## **Core Bus Corridor 16: Ringsend - Preliminary Submission**

### 1.0 Introduction

*Extract of map 3 showing differing pedestrian crossing designs (or mapping errors)*

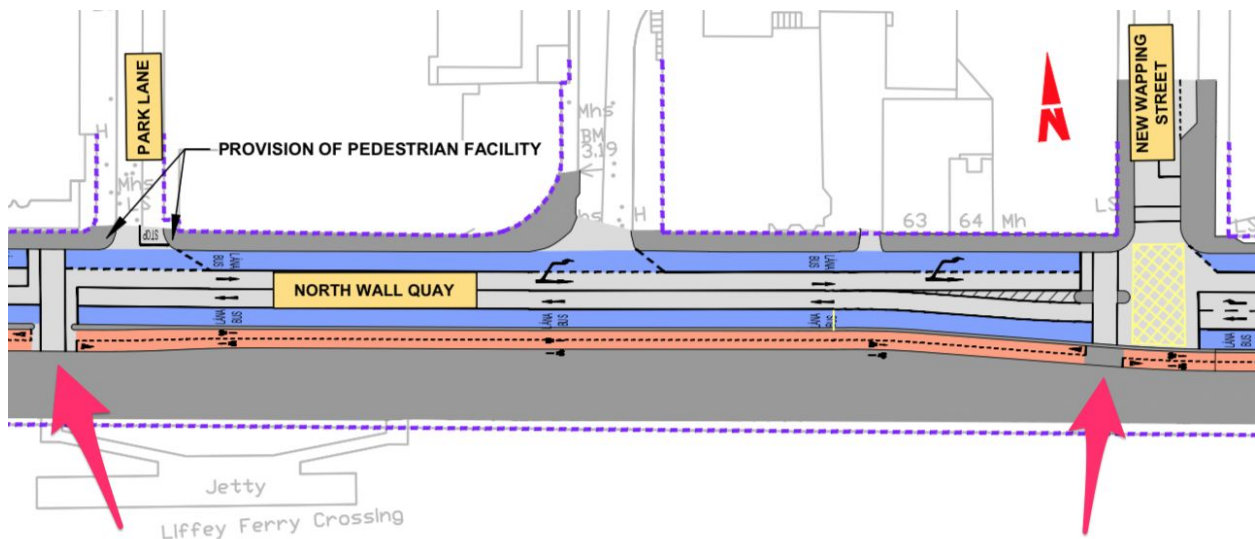
New Wapping Street (map 3) is secondary route 1E of the GDA Cycle Network Plan. It is not clear how a cyclist will be able to connect from New Wapping Street onto the two-way cycle track on the North Campshires. An additional pedestrian/toucan crossing should be considered across North Wall Quay to create a full wrap around crossings. This will also make it easier for cyclists to safely cross onto the two-way cycle track.

We also encourage the design team to remove the shared space (or the mapping error) at the New Wapping pedestrian crossing. Pedestrians should not be forced to wait on the path of the two-way cycle track. This crossing should match the one near Park Lane.

*Extract of the GDA Cycle Network Plan for the Ringsend area*

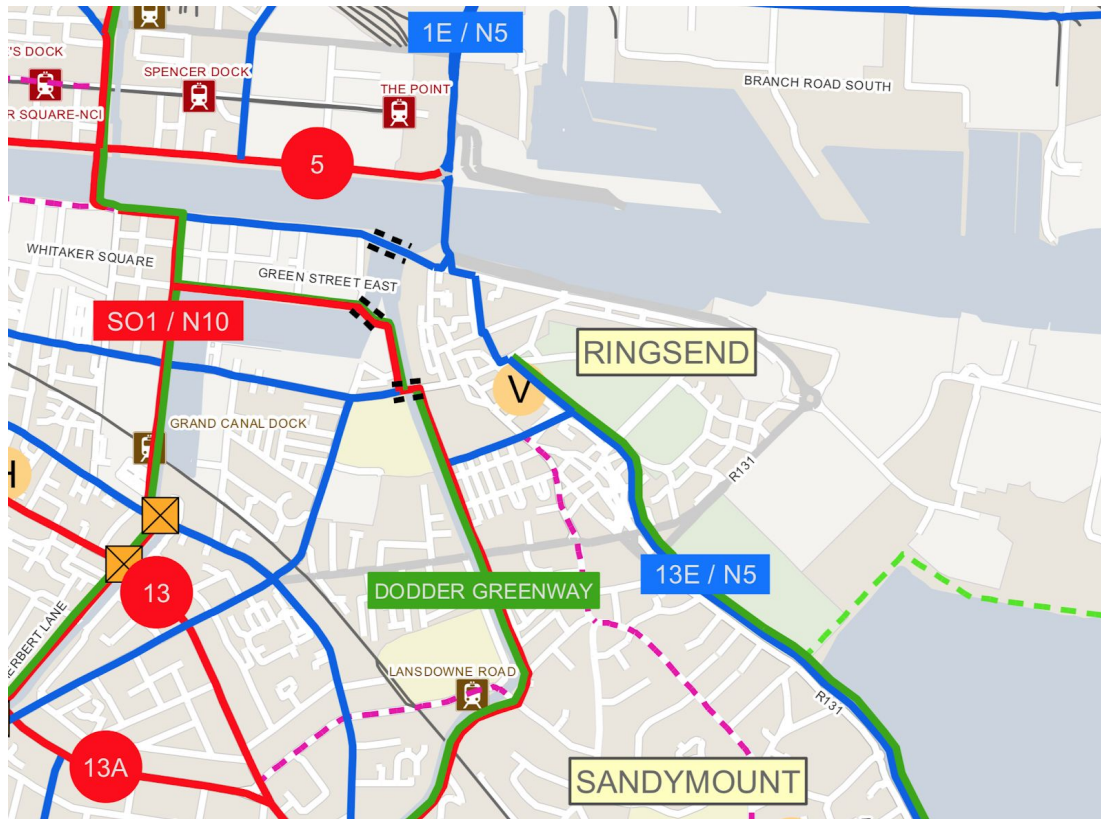
Map 6-10 shows the proposed East Coast Trail. We question why the East Coast Trail is continuing along York Road and runs parallel to Sean Moore Road through Ringsend Park. The proposed route is 1.45km long. The indicative route in the GDA Cycle Network Plan is a more direct through Pembroke Cottages the southern edge of Ringsend Park to Sean Moore Road is 950m long (50% shorter than the proposed route). We understand the emerging preferred route in the options report included bus and cycle lanes all to Sean Moore Road and this may have influenced cycle route choice.

The indicative route in the GDA Cycle Network Plan uses Pembroke Cottages for the East Coast Trail. Since the emerging preferred route of the Dodder Greenway will use Thorncastle street it would be easier to continue the route along the wide Cambridge street to the dedicated cycle facilities planned for Thorncastle Street as part of the Dodder Greenway.
